SCEC – K&A Reviewed
Code B – Approved with Comments (Do not Resubmit)

PROJECT: JEDDAH OPERA HOUSE

TITLE: OPERA BUILDING
VERTICAL TRANSPORTATION
PART 002
PLANS - LIFT SHAFT SHEET 01 OF 02 (L03 & L04)

DRAWING No: JOH-OTS-S5-01-056-002-ZZ-SD-VT-011010 REV: S00

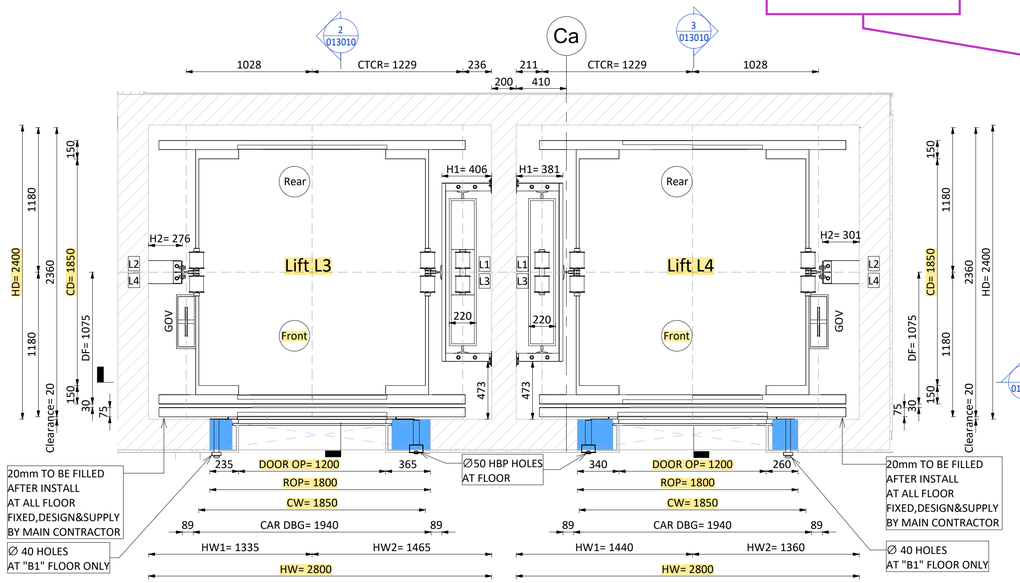
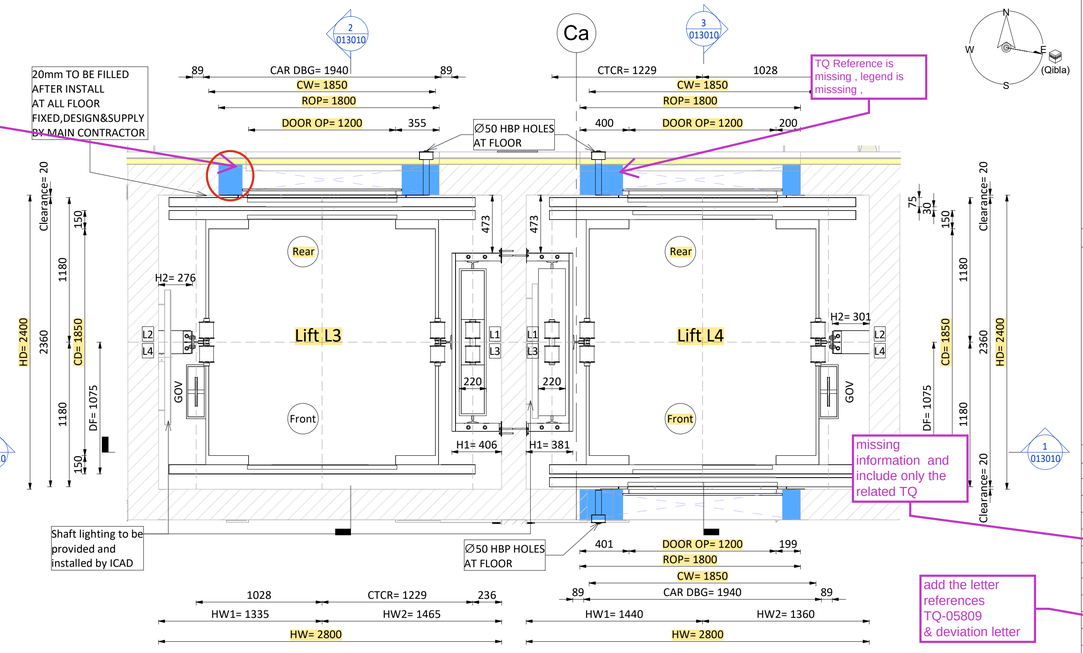
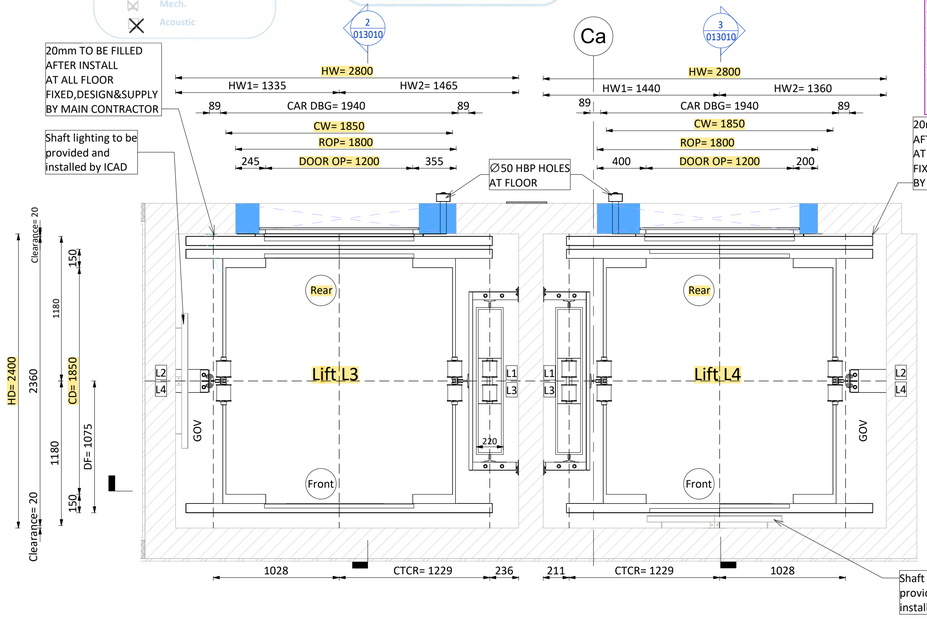
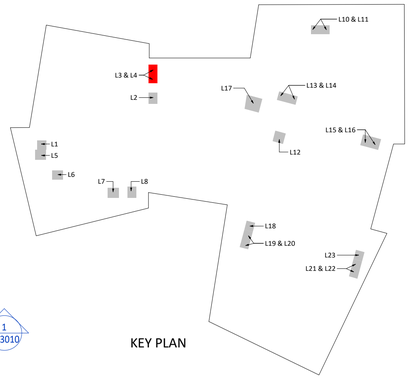
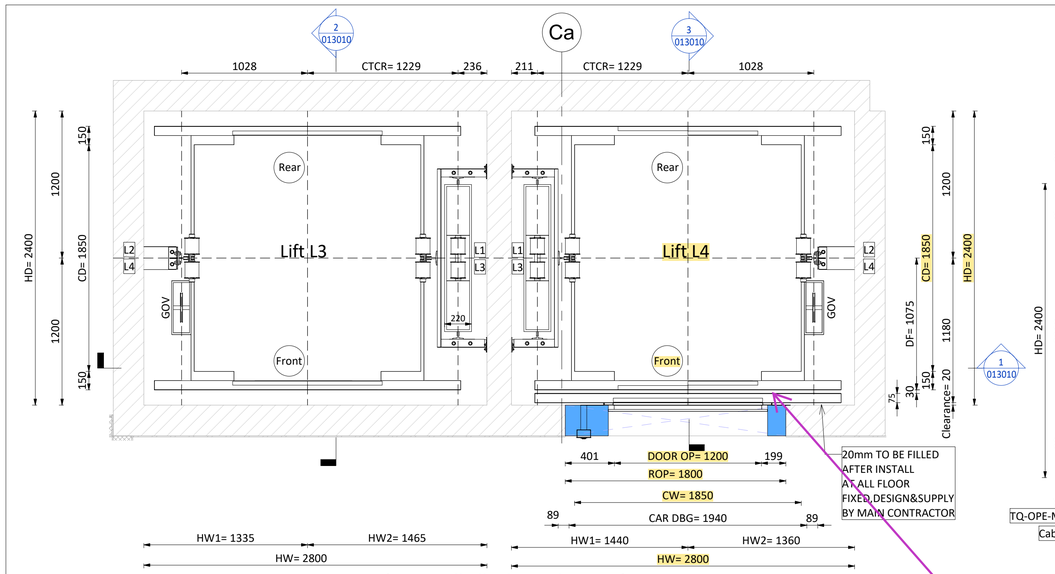
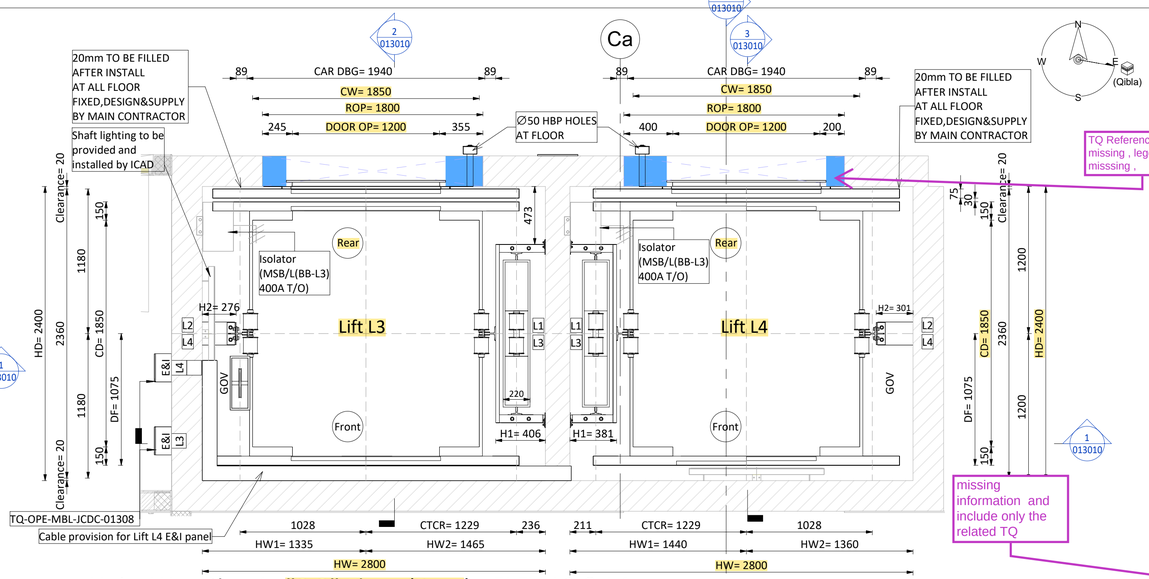
fire stop application detail to be submitted separately for review and FLS approval

1-shaft size to be extracted from federated model
2-contractor must take in consideration as built dimensions and conditions prior execution
3- FFL Levels shall match the federated model levels and as per site conditions
4- Elevator Car Sizes/**dimensions** and Floors Being Served by the Elevators shall be as per approved TBE and further to OTIS letter **TQ-05809** and lift deviation letter ref:**TQ-OPE-MBL-JCDC-01330**
5- car interior finishes shall be submitted in a separate submission for approval
6-HOISTWAY PRESSURIZATION is not provided contractor shall confirm its requirement prior execution
7-Contractor to update the missing reference when submitting the coordination drawing with wall finishing
8-hoistway entrance to be verified by contractor by the contractor to align with OTIS proposed drawings
9-stair ladder shall be submitted separately for approval
Structural comments:
8-Structural design of brackets including their anchor bolts into the concrete walls for the lift loads is to be submitted for checking and approval.

Otherwise, evident for its adequacy is to be provided.

No objection from Electrical side with the following general comments:
1.Contractor to clarify lighting supply requirements and provide locations and provisions for shaft lighting, cabin lighting. emergency lighting, and ventilation fans.
2.Contractor to confirm compatibility with other interfaced systems within the project: BMS, PMS, CCTV, Fire alarm system, Intercom, and cabin speakers as noted on drawings.
3.Contractor to submit wiring diagrams for controller, car operating panel (COP), hall position indicators (HBP), and emergency & inspection panels (E&I).
4.Contractor to clarify the requirements for pit inspection reset switch and fireman service switch installations. (If any Contractor to Provide grounding and earthing details for elevator equipment, guide rails, and machine component.

9-this note is rejected , it is contractor sole responsibility to submit a complete coordinated shop-drawing connection details with wall finishes ,architraves floor threshold connection and liner/top door connection

MBL to provide a comprehensive Method Statement describing the procedure for filling all gaps and correcting / adjusting the rough openings for doors.

fire stop application detail to be submitted separately for review and FLS approval

TQ Reference is missing , legend is misssing ,

missing information and include only the related TQ

add the letter references TQ-05809 & deviation letter

TITLE: OPERA BUILDING
VERTICAL TRANSPORTATION
PART 002
PLANS - LIFT SHAFT SHEET 02 OF 02 (L03 & L04)

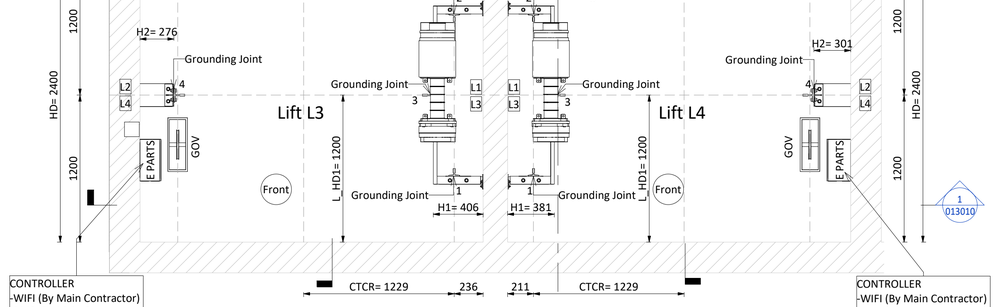
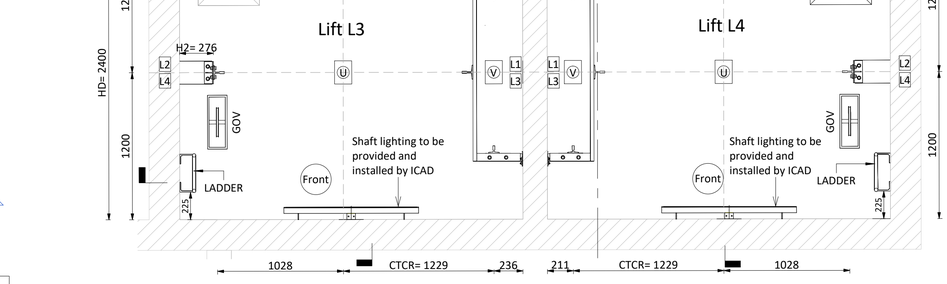
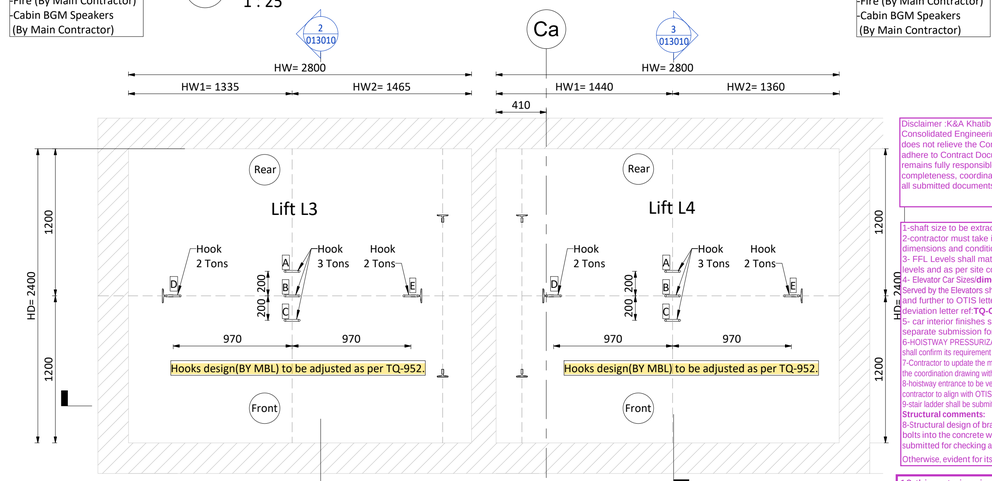
No objection from Electrical side with the following general comments:
1.Contractor to clarify lighting supply requirements and provide locations and provisions for shaft lighting, cabin lighting, emergency lighting, and ventilation fans.
2.Contractor to confirm compatibility with other interfaced systems within the project: BMS, PMS, CCTV, Fire alarm system, Intercom, and cabin speakers as noted on drawings.
3.Contractor to submit wiring diagrams for controller, car operating panel (COP), hall position indicators (HBP), and emergency & inspection panels (E&I).
4.Contractor to clarify the requirements for pit inspection reset switch and fireman service switch installations. (If any Contractor to Provide grounding and earthing details for elevator equipment, guide rails, and machine component.

1-shaft size to be extracted from federated model
2-contractor must take in consideration as built dimensions and conditions prior execution
3- FFL Levels shall match the federated model levels and as per site conditions
4- Elevator Car Sizes/**dimensions** and Floors Being served by the Elevators shall be as per approved TBE and further to OTIS letter **TQ-05809** and lift Deviation letter ref:**TQ-OPE-MBL-JCDC-01330**
5- car interior finishes shall be submitted in a separate submission for approval
6-HOISTWAY PRESSURIZATION is not provided contractor shall confirm its requirement prior execution
7-Contractor to update the missing reference when submitting the coordination drawing with wall finishing
8-hoistway entrance to be verified by contractor by the contractor to align with OTIS proposed drawings
9-stair ladder shall be submitted separately for approval
Structural comments:
8-Structural design of brackets including their anchor bolts into the concrete walls for the lift loads is to be submitted for checking and approval.

Otherwise, evident for its adequacy is to be provided.

MBL to provide a comprehensive Method Statement describing the procedure for filling all gaps and correcting / adjusting the rough openings for doors.

10-this note is rejected , it is contractor sole responsibility to submit a complete coordinated shop-drawing connection details with wall finishes ,architraves floor threshold connection and linter/ top door connection

TITLE: OPERA BUILDING
VERTICAL TRANSPORTATION
PART 002
ELEVATIONS - LIFT SHAFT (L03 & L04)

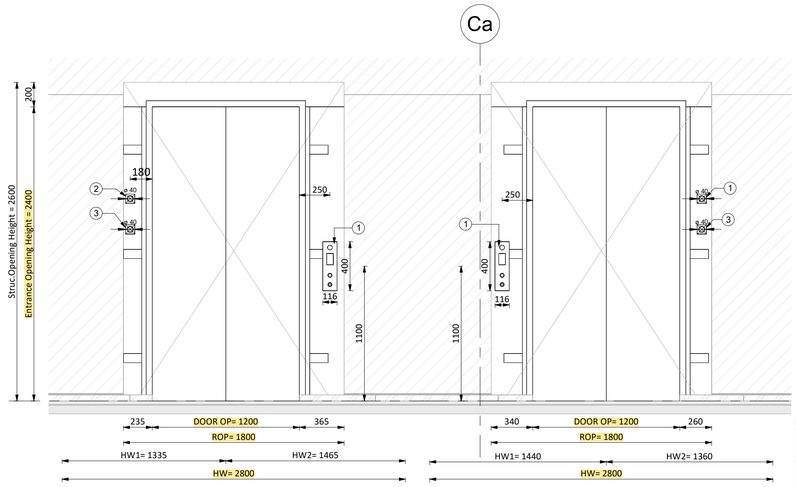
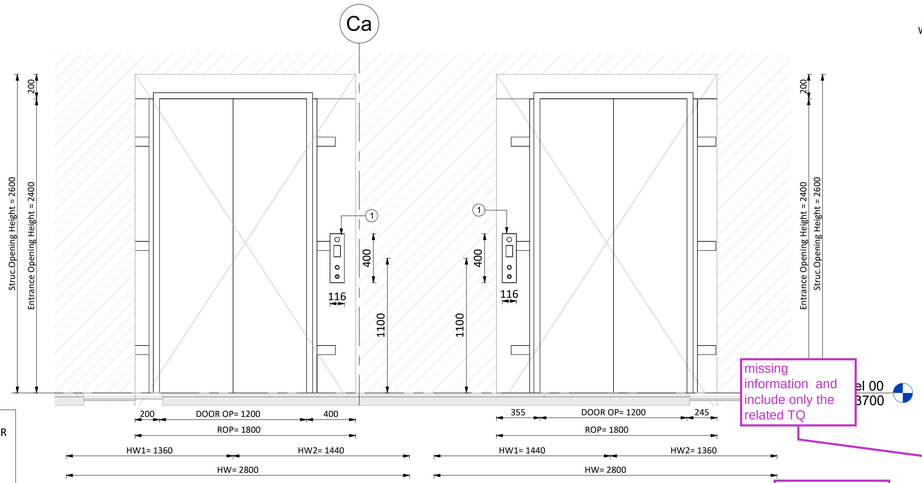
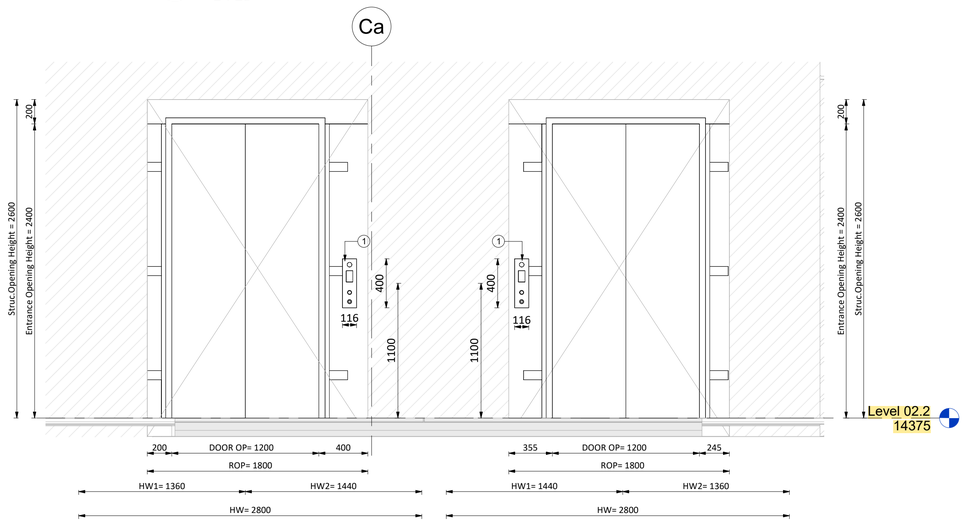
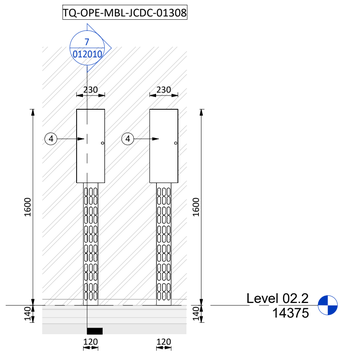
missing information and include only the related TQ

add the letter references TQ-05809 & deviation letter

1-shaft size to be extracted from federated model
2-contractor must take in consideration as built dimensions and conditions prior execution
3- FFL Levels shall match the federated model levels and as per site conditions
4- Elevator Car Sizes/**dimensions** and Floors Being Served by the Elevators shall be as per approved TBE and further to OTIS letter **TQ-05809** and lift deviation letter ref:**TQ-OPE-MBL-JCDC-01330**
5- car interior finishes shall be submitted in a separate submission for approval
6-HOISTWAY PRESSURIZATION is not provided contractor shall confirm its requirement prior execution
7-Contractor to update the missing reference when submitting the coordination drawing with wall finishing
8-hoistway entrance to be verified by contractor by the contractor to align with OTIS proposed drawings
9-stair ladder shall be submitted separately for approval
Structural comments:
8-Structural design of brackets including their anchor bolts into the concrete walls for the lift loads is to be submitted for checking and approval.

Otherwise, evident for its adequacy is to be provided.

No objection from Electrical side with the following general comments:
1.Contractor to clarify lighting supply requirements and provide locations and provisions for shaft lighting, cabin lighting, emergency lighting, and ventilation fans.
2.Contractor to confirm compatibility with other interfaced systems within the project: BMS, PMS, CCTV, Fire alarm system, Intercom, and cabin speakers as noted on drawings.
3.Contractor to submit wiring diagrams for controller, car operating panel (COP), hall position indicators (HBP), and emergency & inspection panels (E&I).
4.Contractor to clarify the requirements for pit inspection reset switch and fireman service switch installations. (If any Contractor to Provide grounding and earthing details for elevator equipment, guide rails, and machine component.

MBL to provide a comprehensive Method Statement describing the procedure for filling all gaps and correcting / adjusting the rough openings for doors.

TITLE: OPERA BUILDING
VERTICAL TRANSPORTATION
PART 002
SECTIONS - LIFT SHAFT (L03 & L04)

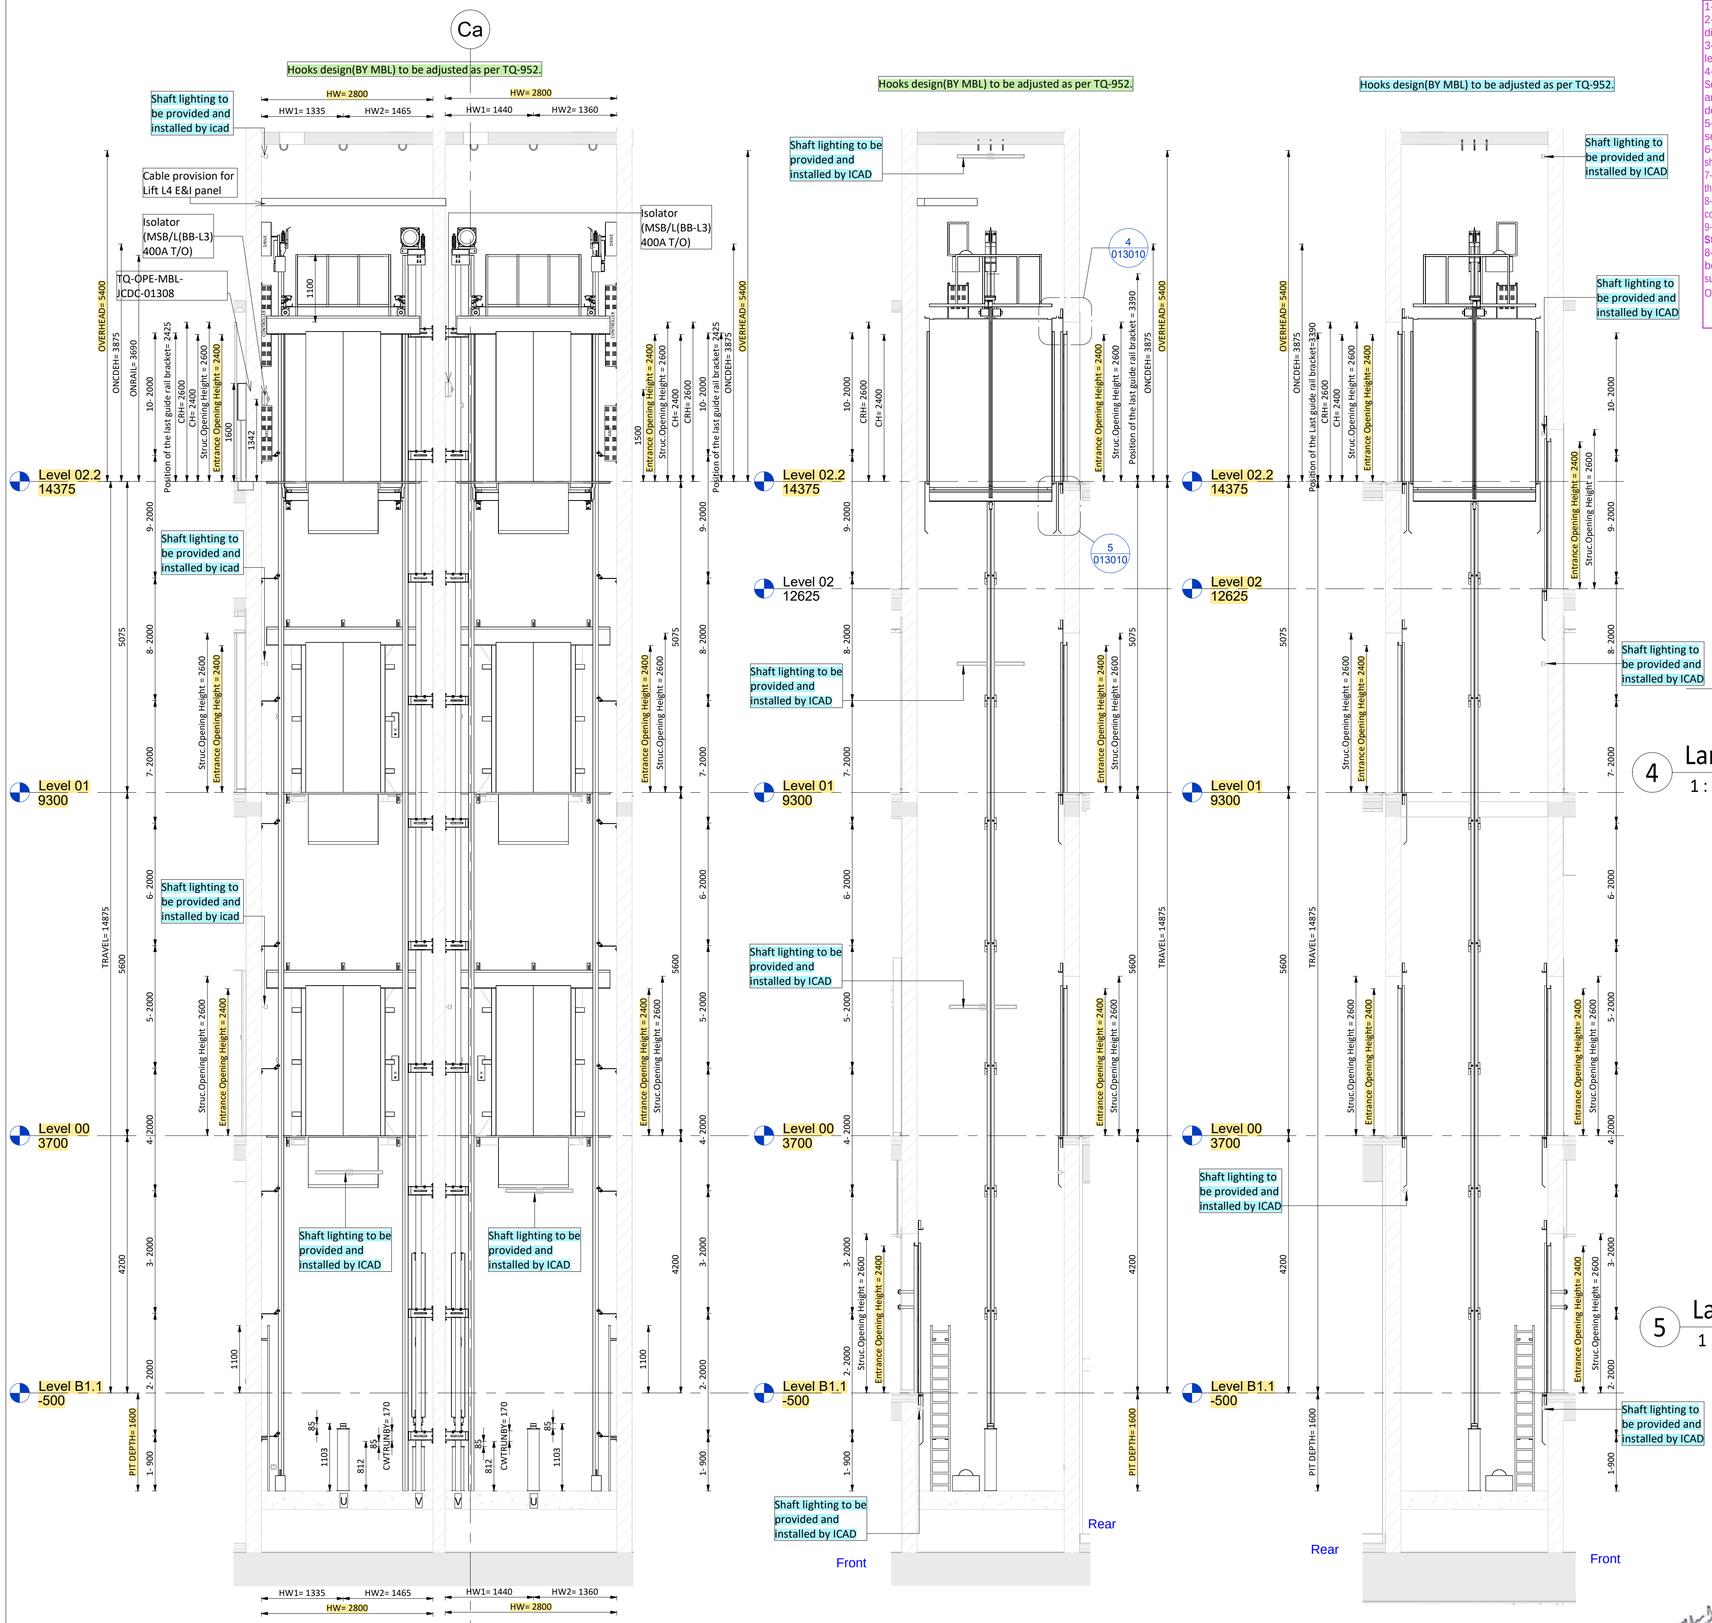
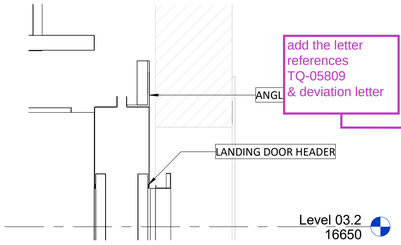
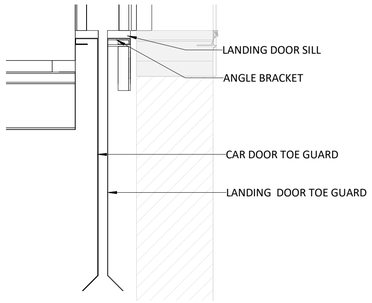
1-shaft size to be extracted from federated model
2-contractor must take in consideration as built dimensions and conditions prior execution
3- FFL Levels shall match the federated model levels and as per site conditions
4- Elevator Car Sizes/**dimensions** and Floors Being Served by the Elevators shall be as per approved TBE and further to OTIS letter **TQ-05809** and lift deviation letter ref:**TQ-OPE-MBL-JCDC-01330**
5- car interior finishes shall be submitted in a separate submission for approval
6-HOISTWAY PRESSURIZATION is not provided contractor shall confirm its requirement prior execution
7-Contractor to update the missing reference when submitting the coordination drawing with wall finishing
8-hoistway entrance to be verified by contractor by the contractor to align with OTIS proposed drawings
9-stair ladder shall be submitted separately for approval
Structural comments:
8-Structural design of brackets including their anchor bolts into the concrete walls for the lift loads is to be submitted for checking and approval.

Otherwise, evident for its adequacy is to be provided.

missing information and include only the related TQ

add the letter references TQ-05809 & deviation letter

No objection from Electrical side with the following general comments:
1.Contractor to clarify lighting supply requirements and provide locations and provisions for shaft lighting, cabin lighting, emergency lighting, and ventilation fans.
2.Contractor to confirm compatibility with other interfaced systems within the project; BMS, PMS, CCTV, Fire alarm system, Intercom, and cabin speakers as noted on drawings.
3.Contractor to submit wiring diagrams for controller, car operating panel (COP), hall position indicators (HBP), and emergency & inspection panels (E&I).
4.Contractor to clarify the requirements for pit inspection reset switch and fireman service switch installations. (If any Contractor to Provide grounding and earthing details for elevator equipment, guide rails, and machine component.
